**BELL BEND NUCLEAR POWER PLANT
FINAL RESPONSE TO ENVIRONMENTAL
REQUESTS FOR ADDITIONAL
INFORMATION TE 4.3-1, TE 4.3-2,
TE 4.3-7, TE 4.3-10, MET 2.7-1, LU 4.1-1,
LU 5.1-1 and LU 5.1-2
BNP-2011-229 Docket No. 52-039**

Responses to Environmental Requests for Additional Information
No. TE 4.3-1, TE 4.3-2, TE 4.3-7, TE 4.3-10, MET 2.7-1, LU 4.1-1, LU 5.1-1 and LU 5.1-2
Bell Bend Nuclear Power Plant

Figure 4.1-1 -BBNPP Site Zoning and Grading Layout

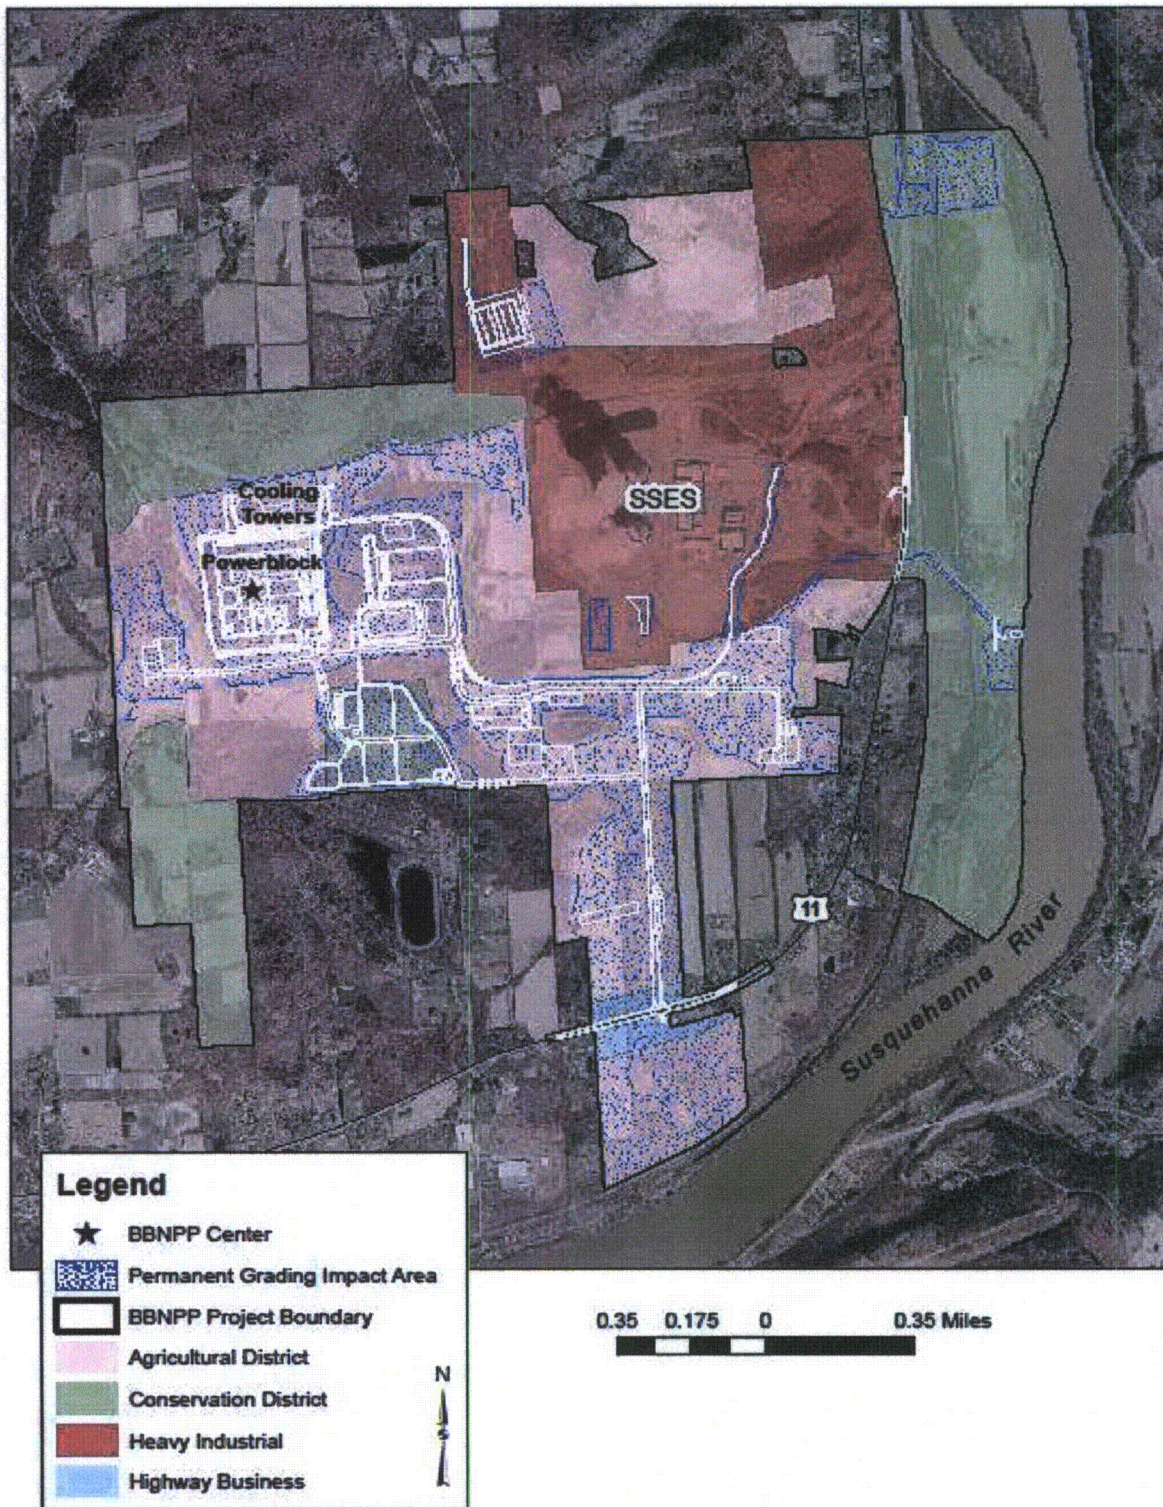
Provide a consistent representation of temporary and permanent grading on all figures.

Full Text (Supporting Information): Address the areal extents of temporary and permanent disturbances that appear inconsistent within the ER: see Figures 4.3-1 and 4.3-2 and compare to Figure 4.1-1 near the proposed intake structure.

It is assumed that all land areas where permanent habitat losses and most temporary habitat losses will occur, along with previously developed areas impacted by construction, will be subject to earth disturbance activities, including clearing, grubbing and grading to varying degrees, and will therefore be classified as grading impact areas as presented in ER Figure 4.1-1. Areas of permanent conversion from one habitat category to another that do not involve earthwork are not considered to be impacted by grading.

Existing ER Figures 4.3-1, 4.3-2, and 4.1-1 have been revised based on the BBNPP Plot Plan Change (PPC) and PPC and Related Grading Changes and any inconsistencies related to the areal extent of temporary or permanent disturbances have been addressed as noted above. ER Figures 4.3-1 and 4.3-2 have also been renumbered as Figures 4.3-2 and 4.3-3 to accommodate a new Figure 4.3-1.

BBNPP COLA ER Figure 4.1-1 will be revised in a future revision of the COLA as shown below. BBNPP COLA ER Figures 4.3-1 and 4.3-2 will be revised in a future revision of the COLA and renumbered as Figures 4.3-2 and 4.3-3, respectively.

Figure 1. 100-year and 500-year floodplains within and in the vicinity of the BBNPP Project Boundary

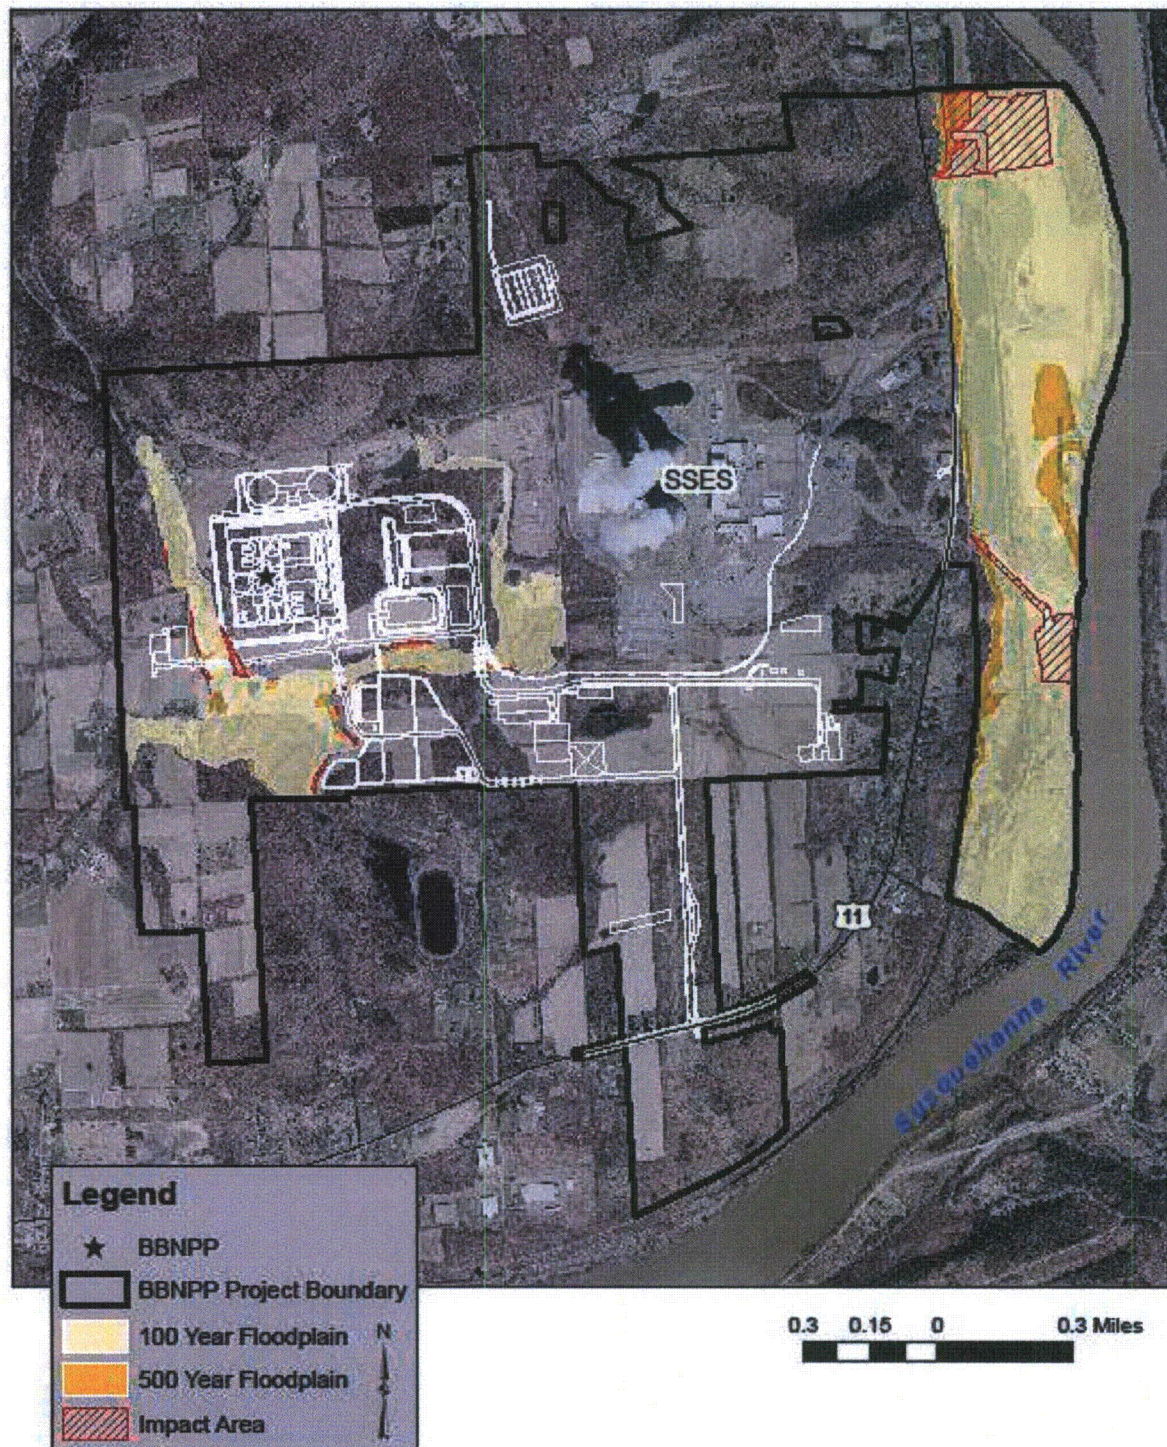
Provide information/figure to quantify the area of 100-year and 500-year floodplains affected by construction.

The BBNPP power block, supporting facilities, and pre-construction 100-year and 500-year floodplains within and in the vicinity of the BBNPP Project Boundary are shown in Figure 1 below. As also detailed in this figure, the floodplains of both Walker Run and the Susquehanna River will be impacted by construction of BBNPP. Proposed construction activities within the Walker Run watershed will affect a total of 0.45 ac (0.18 ha) of the 100-year floodplain and 1.85 ac (0.75 ha) of the 500-year floodplain. For the Susquehanna River watershed a total of 28.1ac (11.4 ha) of the 100-year floodplain and 32.5 ac (13.2 ha) of the 500-year floodplain will be affected. The affected 500-year floodplain acreage includes affected acreage for the 100-year floodplain. Construction activities affecting the floodplains include the installation of temporary and permanent facilities, grading and other earth disturbance work associated with these facilities, and vegetation removal and management.

Figure 1: Construction Impacts to Prime Farmland within the BBNPP Project Boundary

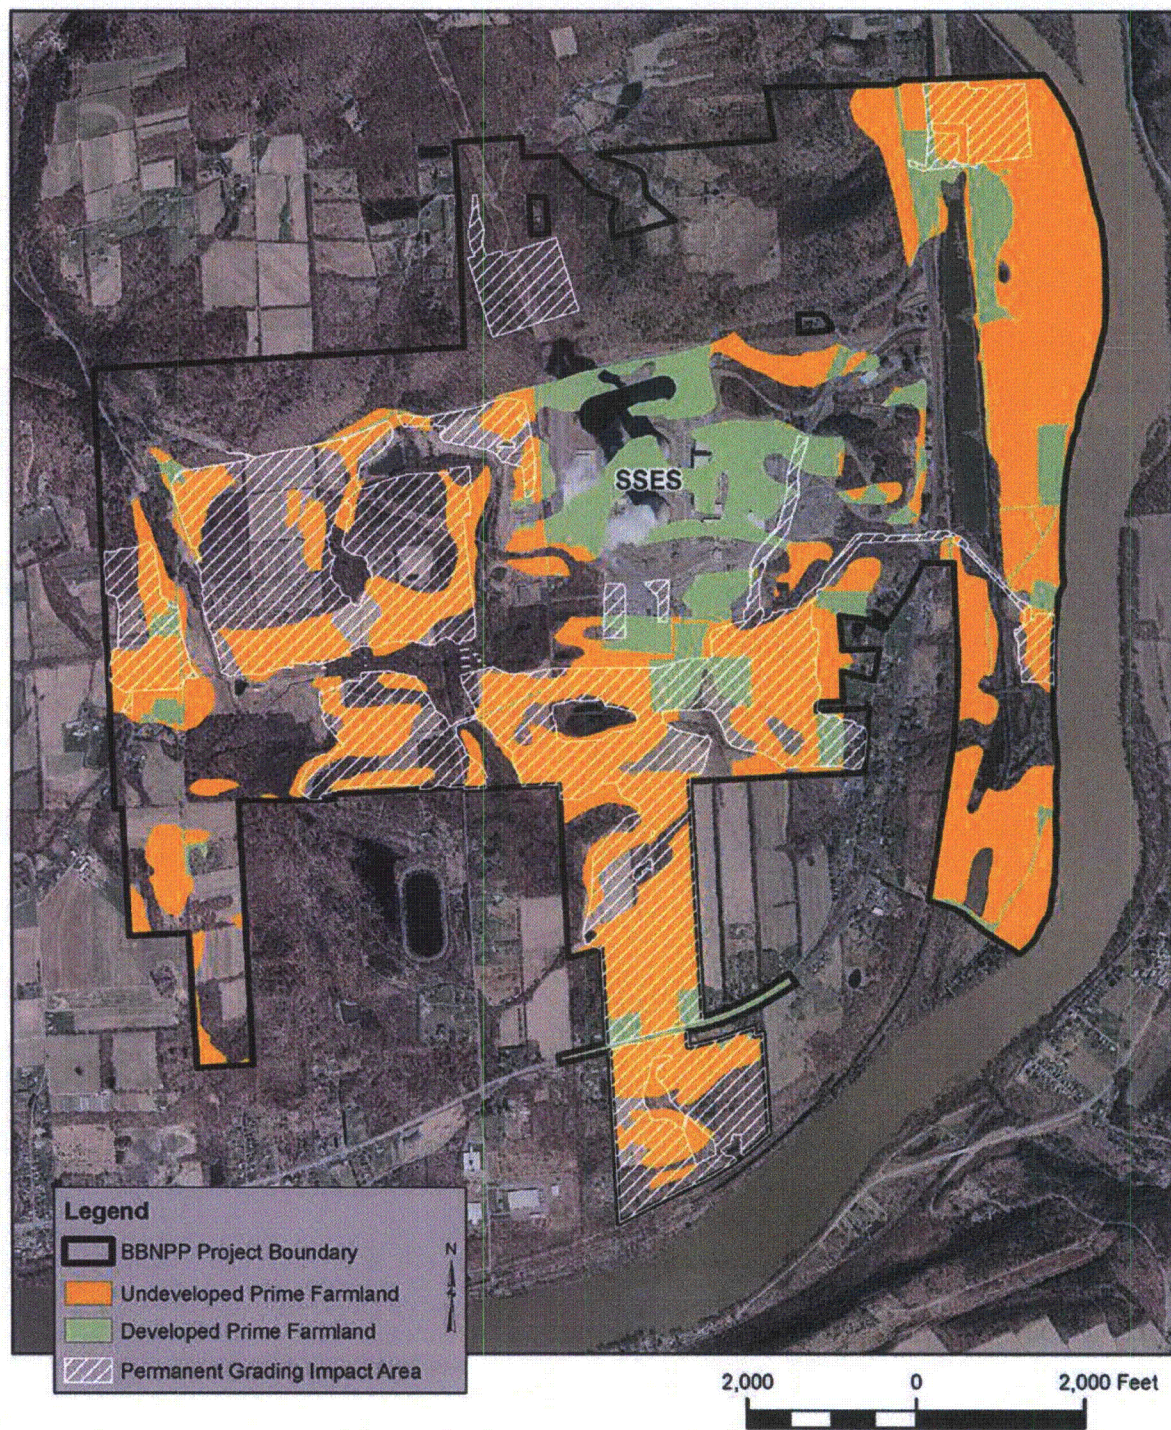
Provide copy of figure identifying location of prime farmland on and near BBNPP site and impacts from construction.

Full Text (Supporting Information): During the site audit, the applicant identified that the project would affect 360 acres of prime farmland based on soil types. The applicant stated that they would provide a copy of the prime farmland figure.

At the site audit, a figure was presented showing the presence of prime farmland soils in the BBNPP Owner Controlled Area (OCA). The figure showed that approximately 360 acres (145.7 hectares) of prime farmland soils were located within the OCA. This original figure was revised as part of this response to include the modified BBNPP Project Boundary, modified location of the powerblock and related structures as a result of the footprint change, and changes to the grading impact area, and is presented below as Figure 1. The revised figure includes an updated list of prime farmland soils (NRCS, 2009). Based on the revised figure, 825 acres (333.9 hectares) of prime farmland soils are located within the BBNPP Project Boundary. However, of the total acreage of prime farmland soils within the Project Boundary approximately 197 acres (79.7 hectares), or roughly 24%, have been previously developed. Developed soils include areas that have been previously graded, excavated, covered, filled, or disturbed in some manner to accommodate residential, commercial, industrial or other non-agricultural structures and facilities.

Figure 1 shows both the developed and undeveloped prime farmland soils that will be impacted by site grading during construction. The figure shows the same grading layout as displayed in ER Figure 4.1-1. Based on the new figure, it is calculated that approximately 324 acres (131.1 hectares) of prime farmland soils will be affected by construction. However, of this amount, only 292 acres (118.2 hectares) represent undeveloped land that has not been previously impacted by non-agricultural uses.

The total area of prime farmland (developed and undeveloped) affected by construction is greater than the approximately 440 acres (178.1 hectares) categorized as in agricultural use in COLA ER Table 2.2-1 (Land Use on the BBNPP Site), primarily because not all of the acreage classified by the prime farmland soils method is classified as in agricultural use according to USGS Land Use and Land Cover data (NRCS, 2009 and USGS, 2008).

Figure 1: Permanent Impacts to Existing Floodplains within the BBNPP Project Boundary

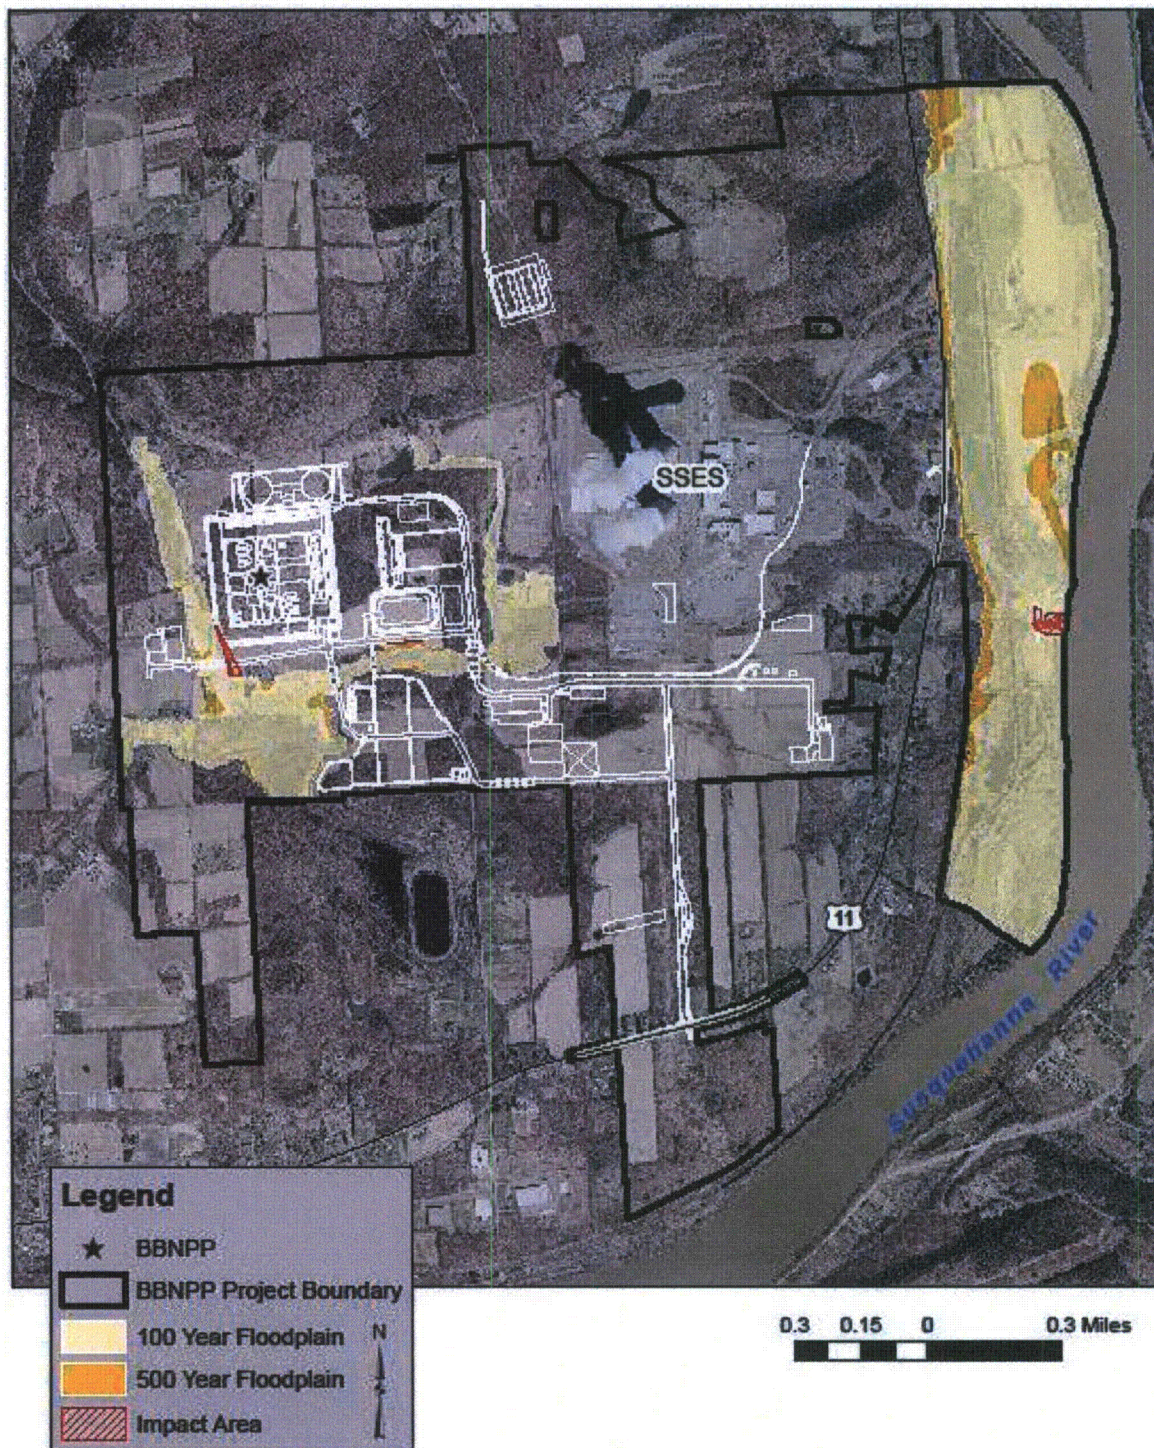
Provide information/figure on 100-year and 500-year floodplains on BBNPP site after construction. Provide information on potential downstream land use impacts due to floodplain changes.

Permanent impacts to the existing 100-year and 500-year floodplains within the BBNPP Project Boundary following construction of BBNPP are shown in Figure 1 below. Construction activities within the Walker Run watershed will permanently impact a total of 0.3 ac (0.12 ha) of the existing 100-year floodplain and 1.0 ac (0.40 ha) of the existing 500-year floodplain, which includes the 100- year floodplain. For the Susquehanna River watershed construction will permanently impact a total of 1.7 ac (0.69 ha) of the existing 100-year floodplain and 1.7 ac (0.69 ha) of the existing 500-year floodplain, which includes the 100-yr floodplain. Permanent floodplain impacts consist of currently known alterations to existing topography within the permanent grading impact area, the addition of permanent structures, pavement or other intensively-maintained exterior grounds, and/or permanent conversions from forested to scrub/shrub land cover.

For the Susquehanna River most construction impacts within the floodplains will be temporary in nature, with the exception of the BBNPP Intake Structure. Most of the construction impacts within the floodplain of Walker Run will be permanent and include a small section of roadway, bridge abutment, and yard area adjacent to the southwest corner of the BBNPP Power Block. The stormwater management plan for BBNPP will utilize infiltration beds to promote groundwater recharge, limit alterations to existing hydrology, and reduce the amount of surface runoff that is discharged directly into Walker Run and the Susquehanna River. Therefore, given the limited permanent impacts to existing floodplains and hydrology within the BBNPP Project Boundary, downstream land use impacts within the Walker Run and Susquehanna River watersheds due to floodplain changes are not anticipated after construction is complete.
